ACCESSION NBR: 8309080054 DOC DATE: 83/08/12 NOTARIZED: NO DOCKET #
 FACIL: 50-397 WPPSS Nuclear Project, Unit 2, Washington Public Powe 05000397
 AUTH. NAME: SORENSEN, G.C. AUTHOR AFFILIATION: Washington Public Power Supply System
 RECIP. NAME: SCHWENCER, A. RECIPIENT AFFILIATION: Licensing Branch 2

Subject: NUCLEAR PROJECT NO. 2
NUREG-0892 SAFETY EVALUATION REPORT,
LICENSING CONDITION (1) ULTIMATE HEAT SINK (UHS)

Attachment 2 is a revision of the WNP-2 FSAR section applicable to the UHS. This revision to the UHS safety evaluation incorporates the results of leakage tests completed February 1983, uses a new minimum pond water level, confirms inclusion of fuel pool heat loads previously considered, and details the plan of operation for the spray ponds that conforms to that described in section 2.4.5 of the WNP-2 Safety Evaluation Report. This revised safety evaluation maximizes heat load and drift and evaporation losses and continues to demonstrate adequate margin for a 30-day supply of water.

PROCEDURE NUMBER	APPROVED	DATE
*8.2.92		
VOLUME NAME		
8	OPERATING AND ENGINEERING TEST PROCEDURES	
SECTION		
8.2	POWER ASCENSION TEST PROGRAM	
TITLE		
*8.2.92	ULTIMATE HEAT SINK PERFORMAN

FIGURE
9.2-8

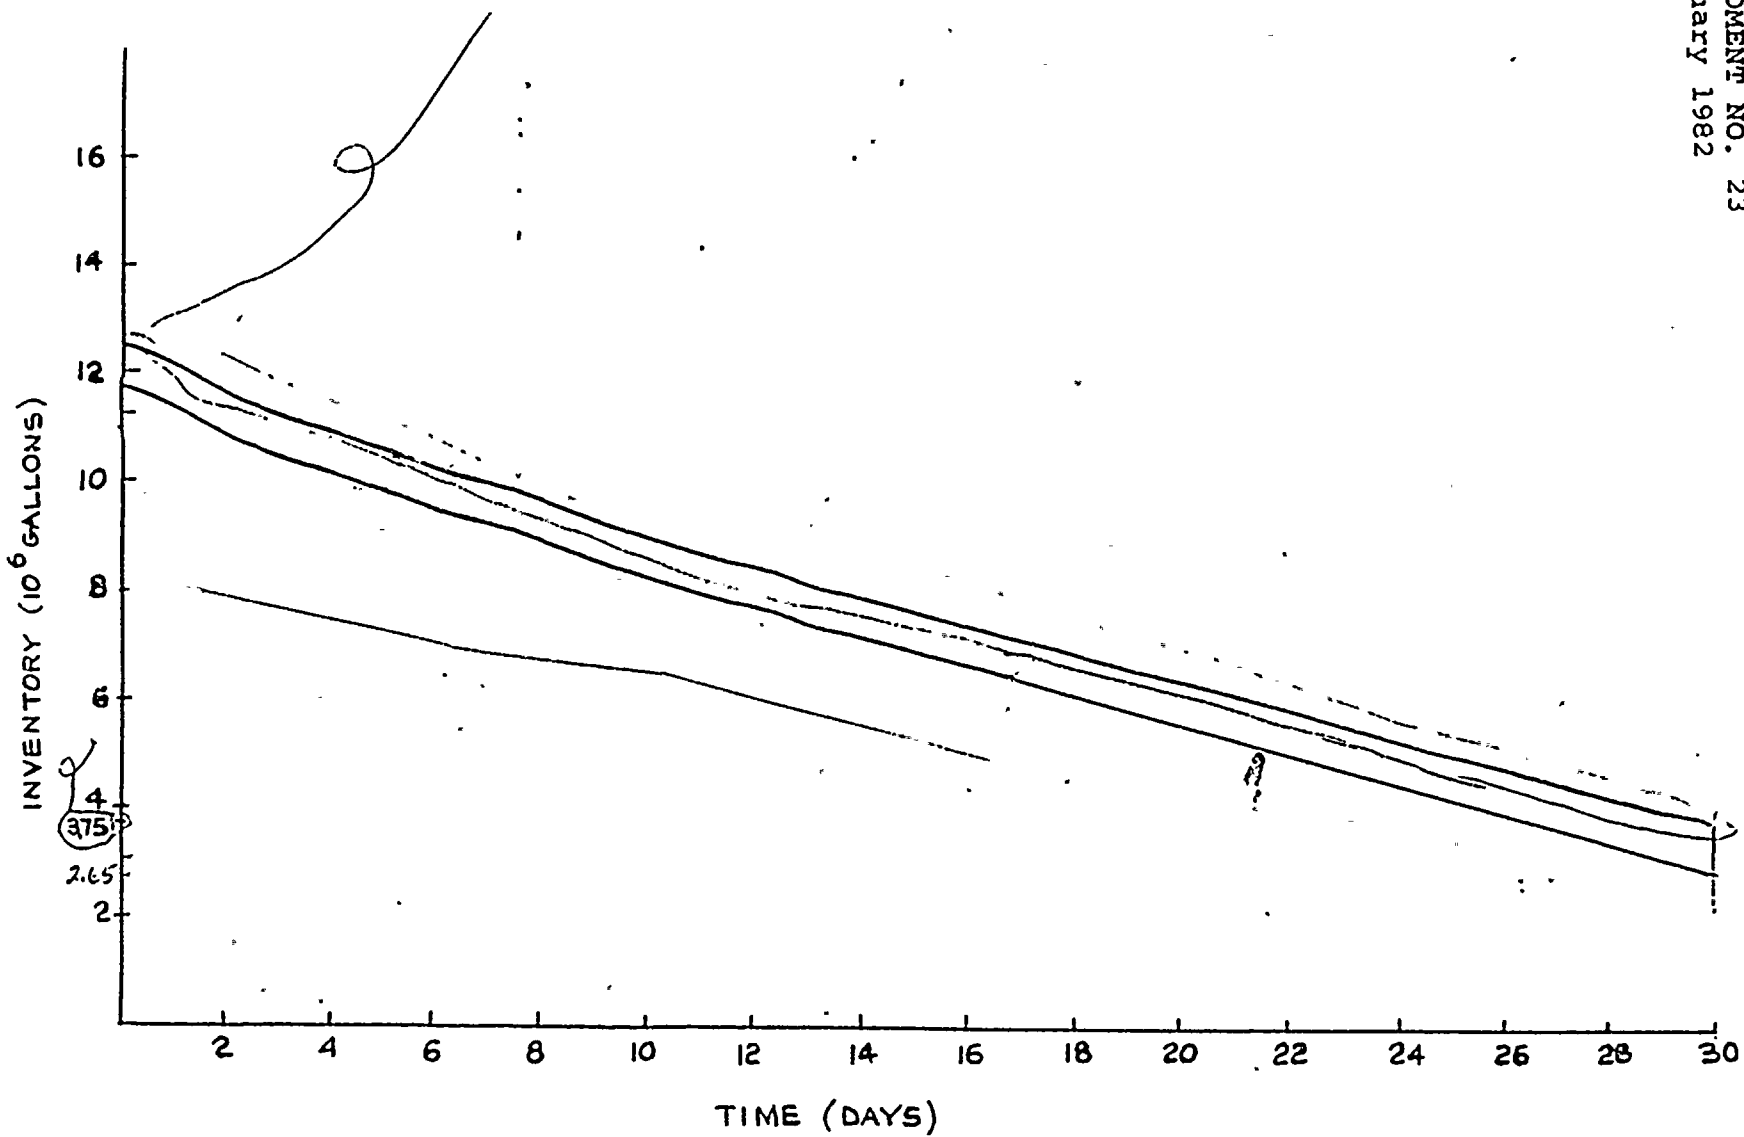
The results of the ^{design basis} mass loss analysis assuming an unfouled heat exchanger is shown in Figure 9.2-8 and is tabulated in Table 9.2-3. For the design basis mass loss analysis, remaining pond volume (both ponds) is 2.65×10^6 gal. With 1.4×10^6 gal. required for operation of the system, the water remaining is 1.25×10^6 gal. Drift losses following loss of makeup to the ponds are may be controlled during two spray ring operations by bypassing the spray header on one pond whenever spray pond temperatures drop below approximately 80°F. Continuous, simultaneous operation of both spray rings is not required after a LOCA. Since the two SW loops are redundant to each other, the operators will be able to secure any redundant safe shutdown equipment when they determine that the peak temperatures have been past. In addition, the difference between assumed and calculated drift losses for continuous operation of one spray ring, is more than adequate to account for drift losses from the operation of the second spray ring or several days after the accident.
